Re: Docket No. 516 – The United Illuminating Company Application for a Certificate of Environmental Compatibility and Public Need for the Fairfield to Congress Railroad Transmission Line 115-kV Rebuild Project

Interrogatory BWC-1

CROSS SECTION AT P724S

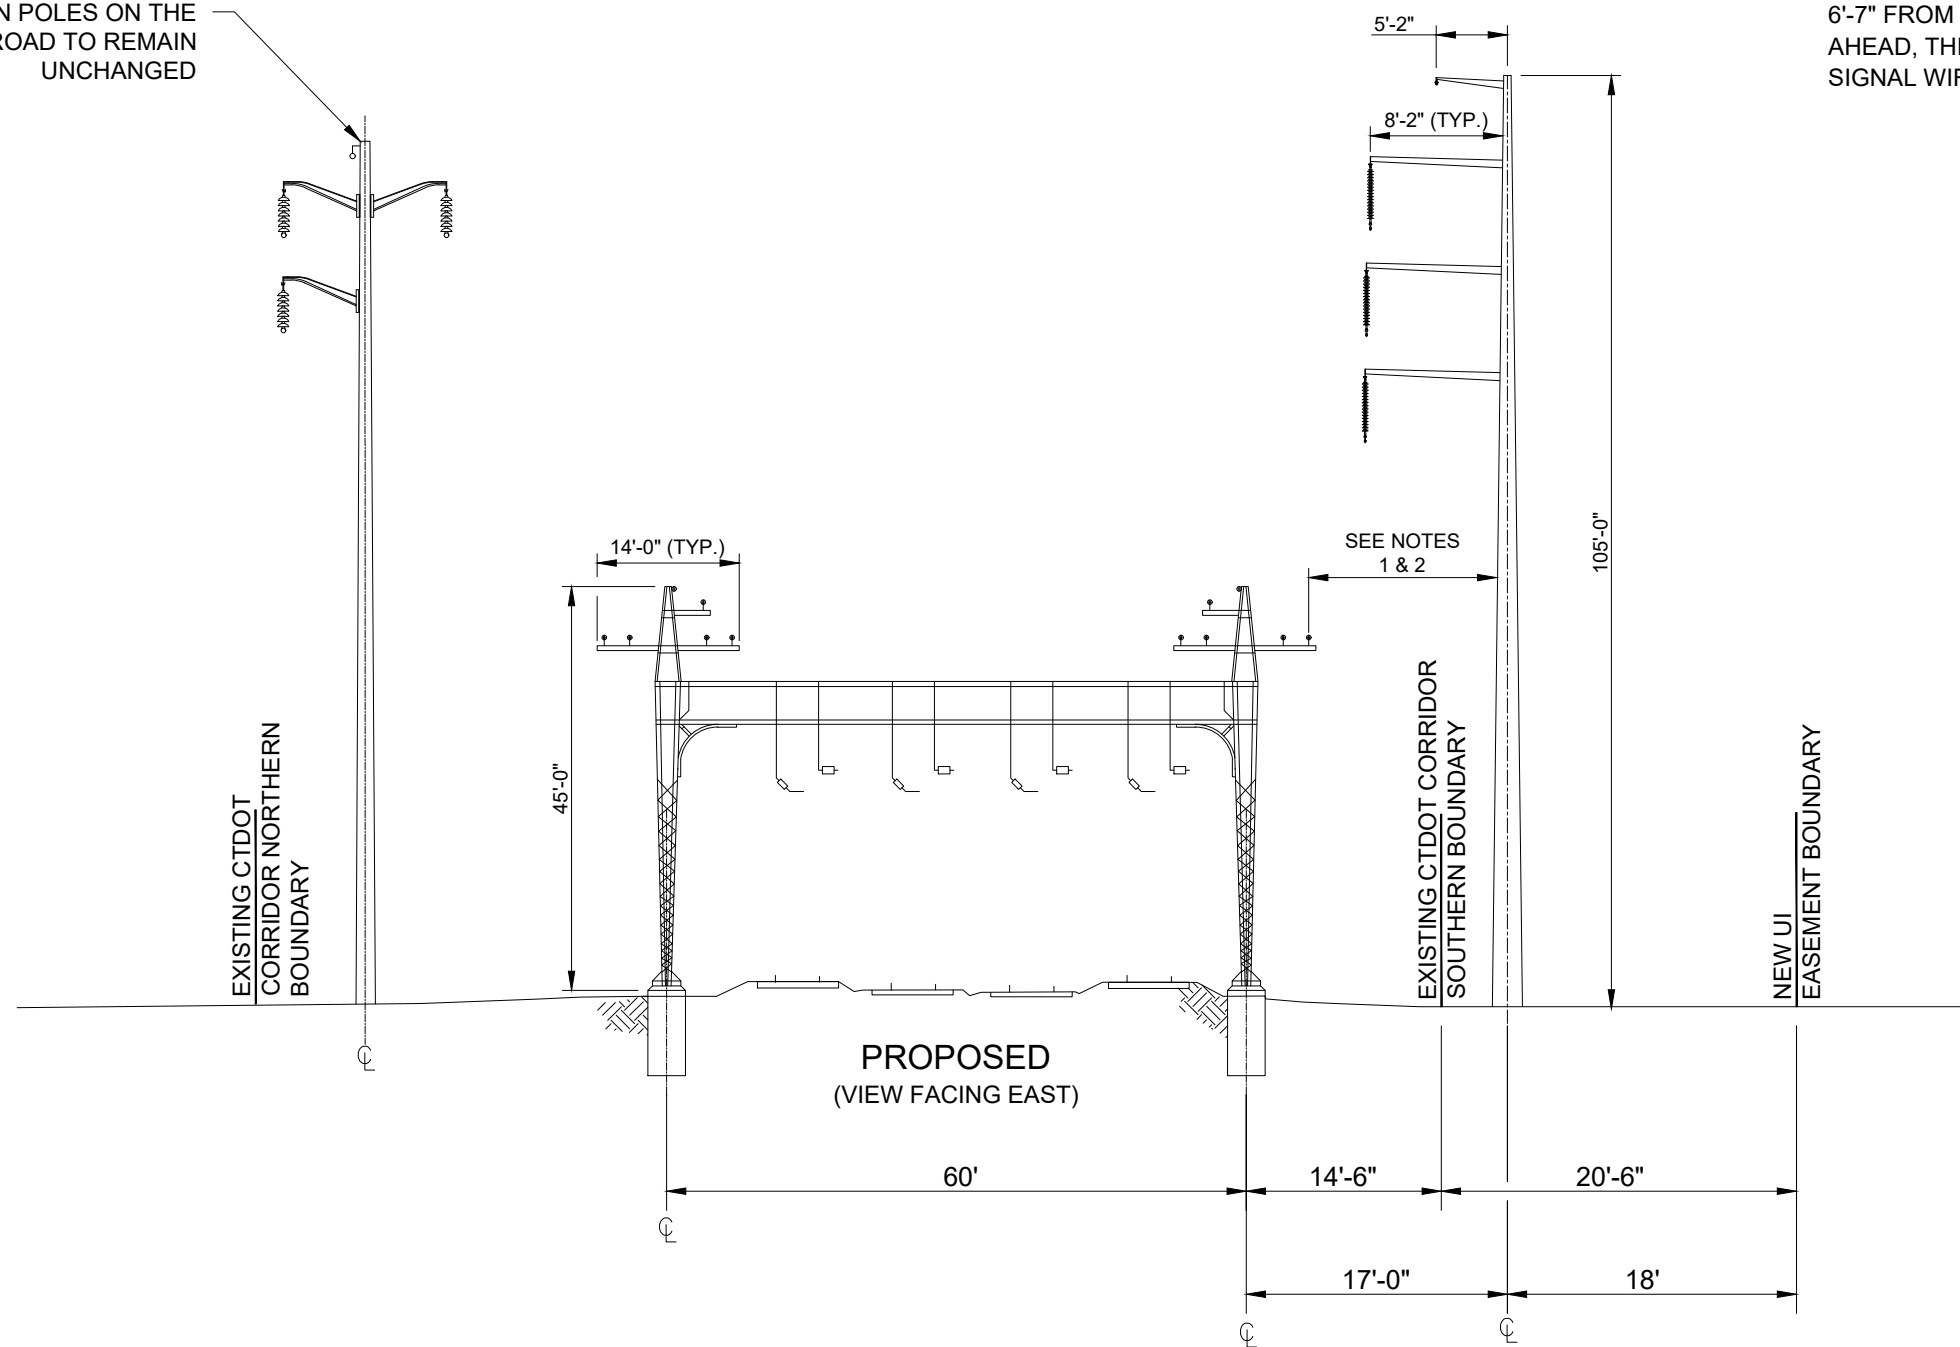
Q-BWC-7: Please describe and provide BWC with cross-sections, including the required clearances between the wires (horizontal and vertical) and other critical obstructions, to illustrate the relationship between the proposed locations of the transmission lines to the wires and fixed objects on the MTA's property.

A-BWC-7: Please see Attachments BWC-7-1 and BWC-7-2.

1. THE CLEARANCE REQUIREMENT BETWEEN METRO NORTH SIGNAL WIRES AND FACE OF POLE UNDER NO WIND IS 5'-11". CURRENT DESIGN PLACES POLE FACE 9'-0" FROM METRO NORTH SIGNAL WIRES.
2. THE CLEARANCE REQUIREMENT BETWEEN METRO NORTH SIGNAL WIRES AND FACE OF POLE UNDER 6 PSF (48.4 MPH) BLOWOUT WIND CONDITIONS IS 5'-5". CURRENT DESIGN PLACES POLE FACE 6'-7" FROM METRO NORTH SIGNAL WIRES. IF POLE IS MOVED 9' AHEAD, THE POLE FACE WOULD BE 7'-5" FROM METRO NORTH SIGNAL WIRES
